Part Number: **148015**

Description: **FENCE ASSEMBLY,CHAIN LINK,YODOCK**

**Specification:**

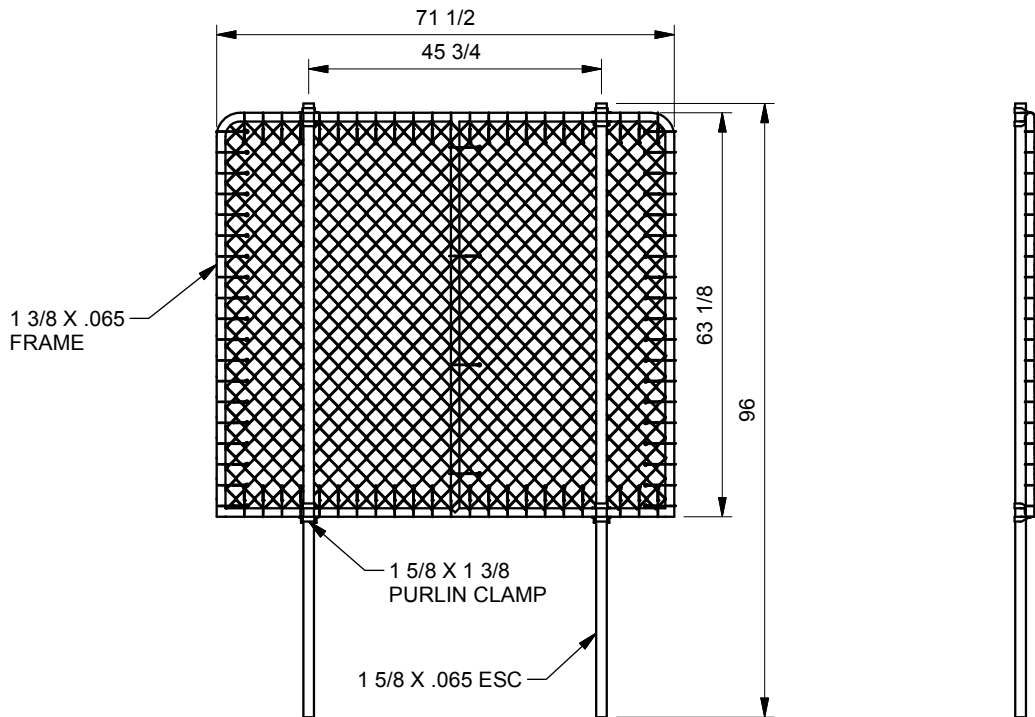
Revision Description	ECO	Rev	By	Date	Eng	Pur
Moved Stephens Pipe & Steel from Approved Manufacturer to Vendor Reference, checked the "Does Not Apply" Box above.	5384	B	DDS	5/21/18	CGB	JLC
Updated image to incorporate new size of panel, (was 60x72), updated body of spec to include fabric and tie specifications	5429	C	DDS	7/10/18	CGB	JLC
UPDATED SPEC FORM, ADDED GALVANIZING NOTE TO SPECIFICATON, ADDED "ADDITIONAL ITEMS TO BE INCLUDED: ....."	6065	D	RJV	9/4/18	ARVB	JLC

A fence panel to supplement the Yodock 2001 series barriers. (All material and hardware to be galvanized per manufacturing specifications)  
Fabric to be 11.5 GA 1V, laced or tied at each eyelet on top, bottom and sides of frame, with 4 ties on center support, spaced equally.  
Fabric to fill framework; 68.75" x 60.375".
